South Texas Project  
Unit 1  
Docket No. STN 50-498  
Relief Request RR-ENG-2-30, Rev. 2

**10CFR50.55a Relief Request RR-ENG-2-30, Rev. 2****Proposed Alternative  
in Accordance with 10 CFR 50.55a(a)(3)(i)****--Alternative Provides Acceptable Level of Quality and Safety--****1. ASME Code Components Affected**

**Response to Informal Request for Additional Information for  
South Texas Project Underwater Welding (RR-ENG-2-30)**

**SCHEMATIC  
NOT TO SCALE**

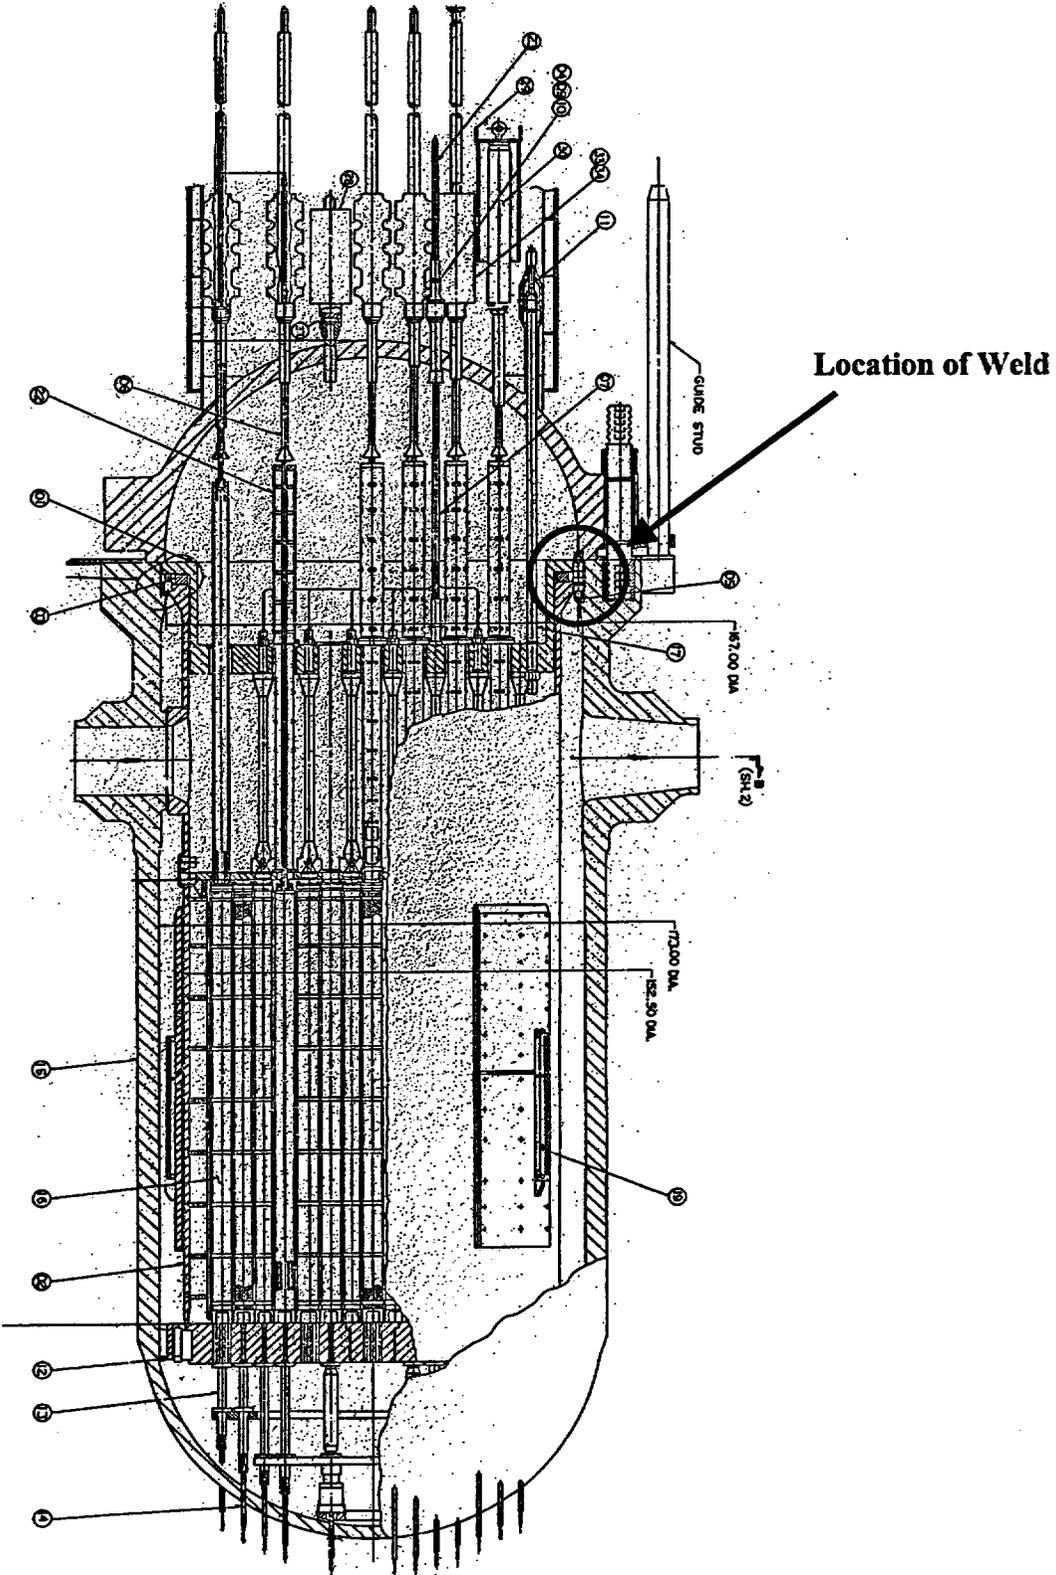
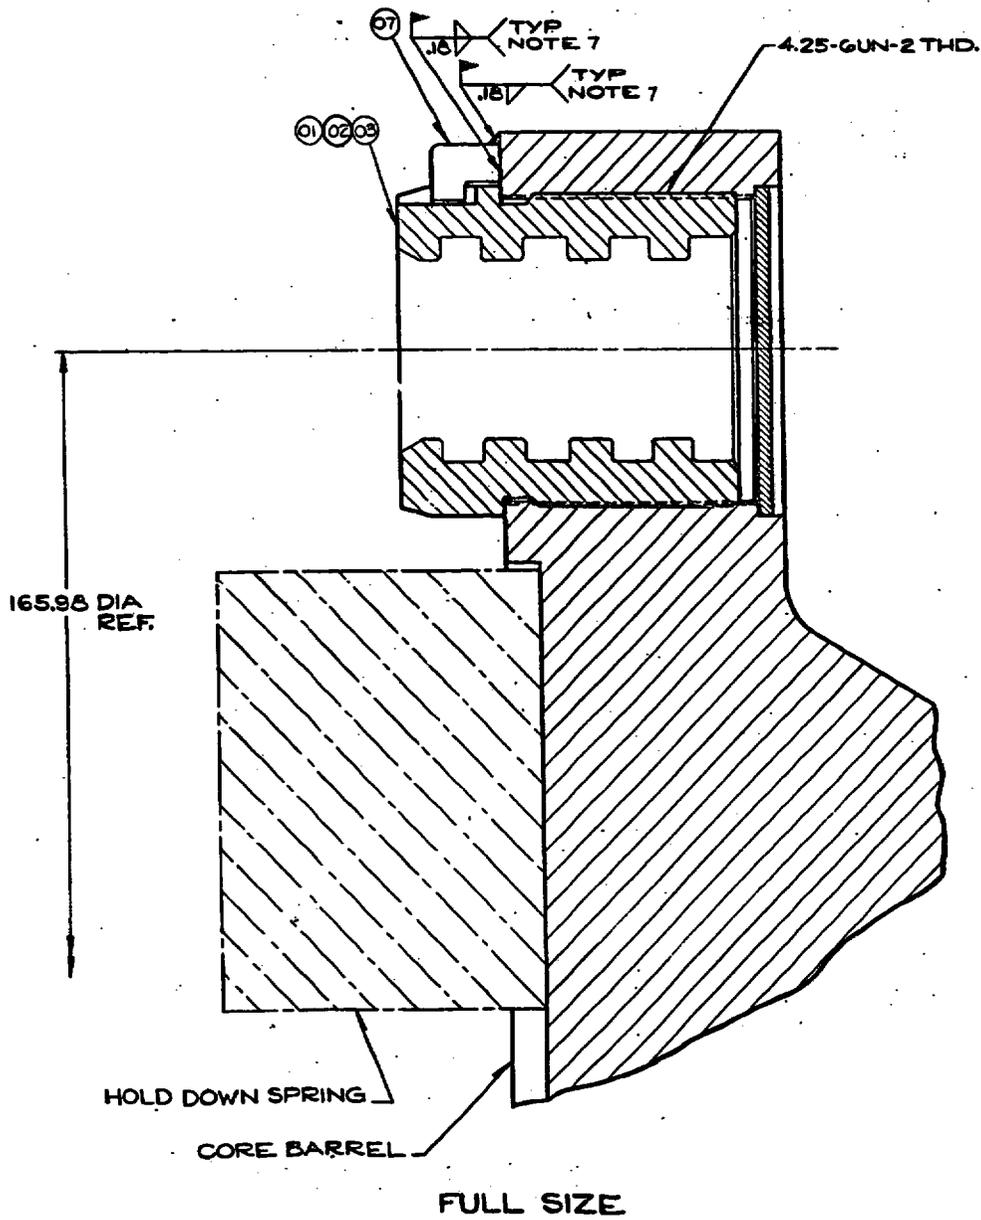
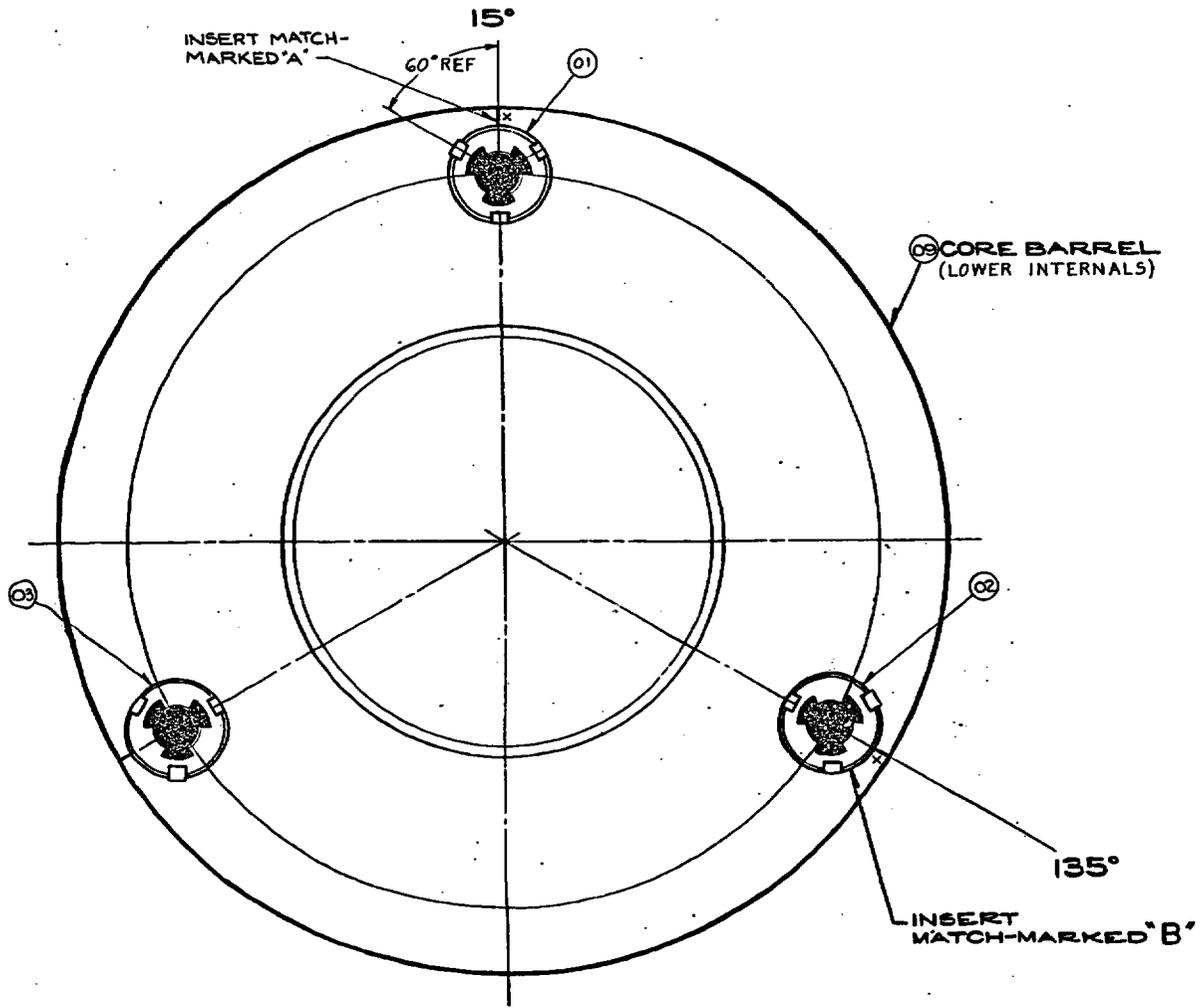
3. What is the specific item to be welded using underwater welding?

**Response: Code Case N-516-2 was used for making three underwater fillet welds to attach one Roto-Lock insert locking tab to the core barrel to secure the Roto-Lock insert and prevent its rotation.**
